TECHNICAL BULLETIN

No. 206L-08-230

MODEL AFFECTED: 206L-1 and 206L-3

SUBJECT: ELECTRONIC ENGINE N2 OVERSPEED PROTECTION SYSTEM, REMOVAL OF

FIGURE 1 – Typical 206L-1 and 206L-3 Configurations (Sheet 1 of 2)

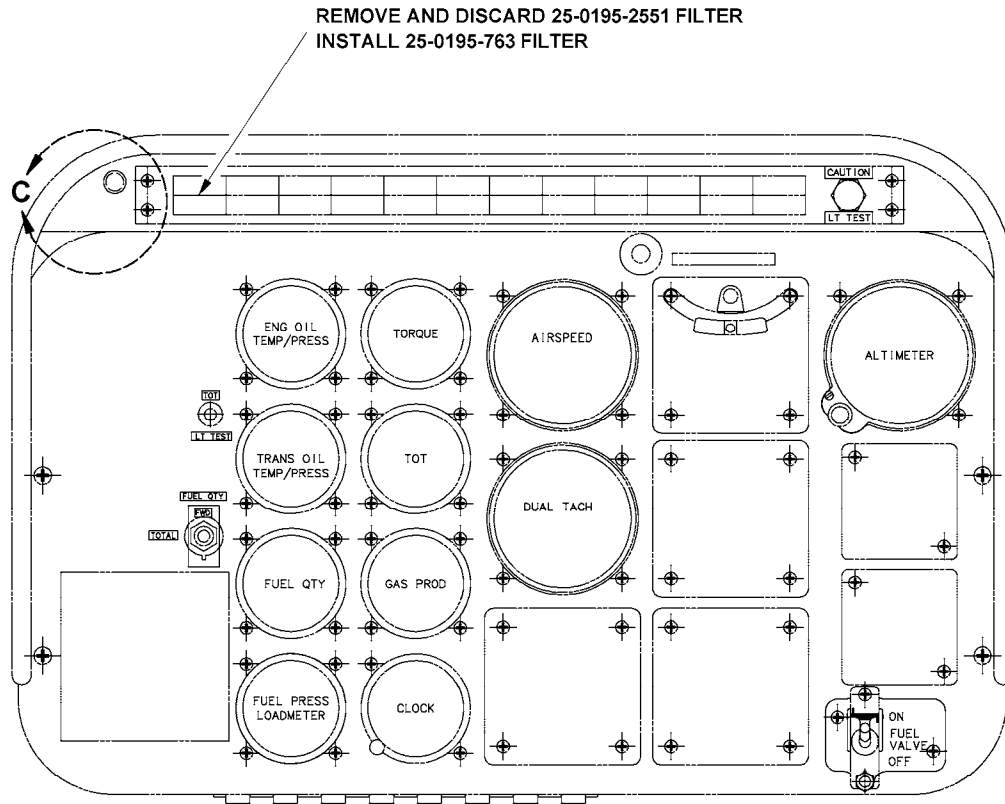
3. Remove and discard filter P/N 25-0195-2551 from caution warning panel and install filter P/N 25-0195-763. (Refer to Figure 1)
4. Remove and discard switch 1S10, decal P/N 31-030-24D12, and install plug button P/N 100-050B375 in lieu of the switch. (Refer to Figure 1, view C)

5. Remove and discard circuit breaker 1CB13 and install plug button 100-050B500 in its place. (Refer to Figure 1)
6. If installed, remove decals "ENG N2 OVSP DSARM" (Refer to ASB 206L-81-24) and/or "ENG OVSP CIRCUIT DEACTIVATED" (Refer to CEB A-73-2020) located on the overhead panel adjacent to ENG OVSP circuit breaker and on the instrument panel adjacent to the Overspeed test switch.

REMOVE AND DISCARD SWITCH 1S10
REMOVE AND DISCARD 31-030-24D12 DECAL
INSTALL 100-050B375 PLUG BUTTON
